SUNDRY NOTICES AND REPORTS ON WELLS
Do not use this form for proposals to drill or to re-enter an abandoned well. Use Form 3160-3 (APD) for such proposals.

OPERATOR Seely Oil Company
WELL NO. 202
API 3002502373

Conditions of Approval

Seely Oil Company
EK Penrose Sand Unit
API 3002502373, T18S-R34E, Sec 30

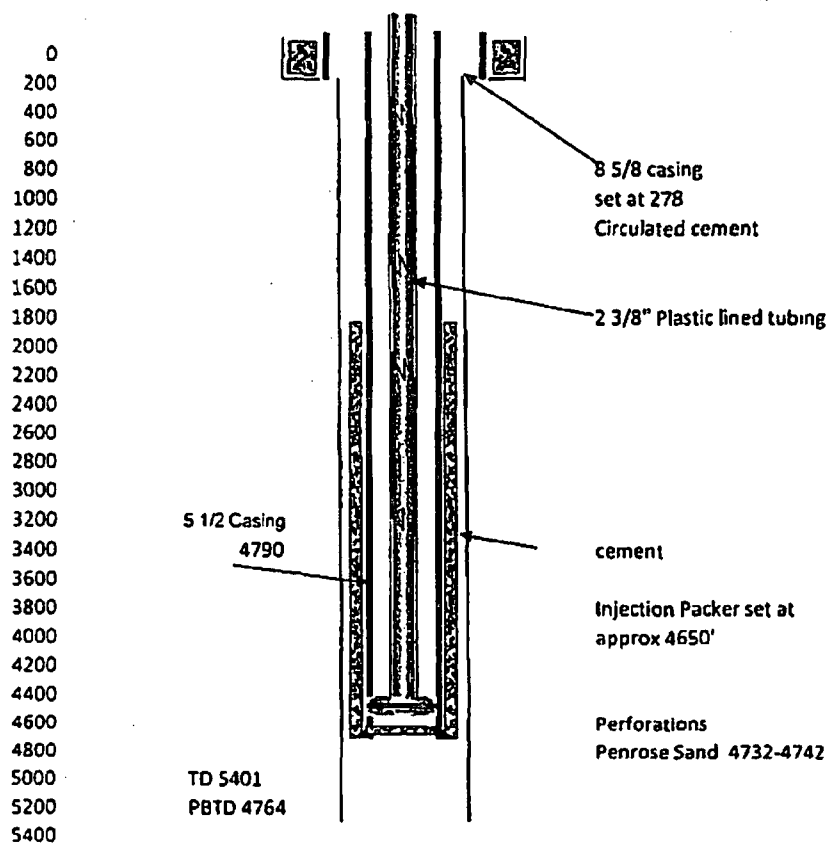
3. **Confirm the plug back total depth with a work string tally and report that depth in the subsequent sundry.**
4. **Provide BLM with an electronic copy (Adobe Acrobat Document) cement bond log record from 4700 or below to top of cement. The CBL may be attached to a pswartz@blm.gov email.**

- 1) **Conduct a Mechanical Integrity Test** of the tubing/casing annulus after a tubing, packer or casing seal is established. Repair that seal any time more than five barrels of packer fluid is replaced within 30 days.

- 2) **The minimum test pressure should be 500 psig for 30 minutes** or 300 psig for 60 minutes, with a minimum 200 psig differential between tubing and casing pressure (at test time) but no more than 70% of casing burst pressure as described by Onshore Order 2.III.B.1.h. (The tubing or reservoir pressure may need to be reduced). An alternate method for a BLM approved MIT is to have the fluid filled system open to atmospheric pressure and have a loss of less than five barrels in 30 days witnessed by a BLM authorized officer.

- 3) **Document the pressure test on a one hour full rotation calibrated recorder chart** registering within 25 to 85 per cent of its full range. Greater than 10% pressure leakoff will be viewed as a failed MIT. Less than 10% pressure leakoff will be evaluated site specifically and may restrict injection approval.
